PCN#20180329000B
Qualify TI Mexico as an additional Assembly & Test site
for select PDIP devices
Change Notification / Sample Request

Date: June 10, 2019
To: TOKYO ELECTRON DEVICE (DSTR) PCN

PCN Number:	20180329000B	PCN Date:	June 10, 2019
Title:	Qualify TI Mexico as an additional Assembly & Test site for select PDIP devices		
Customer Contact:	PCN Manager	Dept:	Quality Services
Change Type:			
☒ Assembly Site	☐ Design	☐ Wafer Bump Site	
☐ Assembly Process	☐ Data Sheet	☐ Wafer Bump Material	
☐ Assembly Materials	☐ Part number change	☐ Wafer Bump Process	
☐ Mechanical Specification	☒ Test Site	☐ Wafer Fab Site	
☒ Packing/Shipping/Labeling	☐ Test Process	☐ Wafer Fab Materials	
		☐ Wafer Fab Process

Marking Differences:

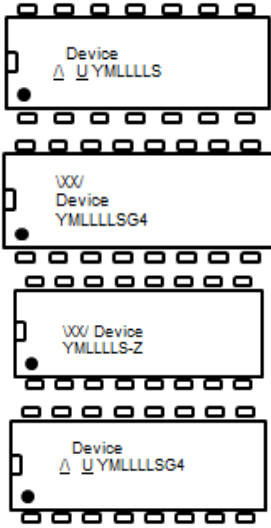
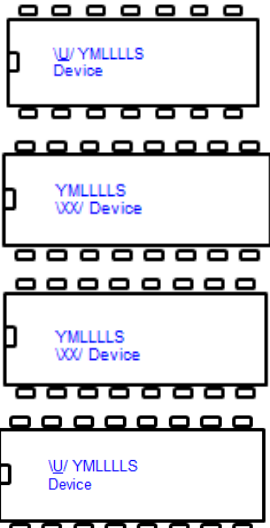
Revision B is to update the affected device list that does Not require a marking change in the Product Affected Section under Group 1 and highlighted in **Blue**. These devices will keep their existing marking format. We apologize for any inconvenience this may have caused.

Texas Instruments is pleased to announce the qualification of TI Mexico as an additional Assembly & Test site for the list of devices shown below. Material differences between sites are as follows.

Carsem	TI Mexico
Group 1 Device		
Group 2 Device

Group 3 Device
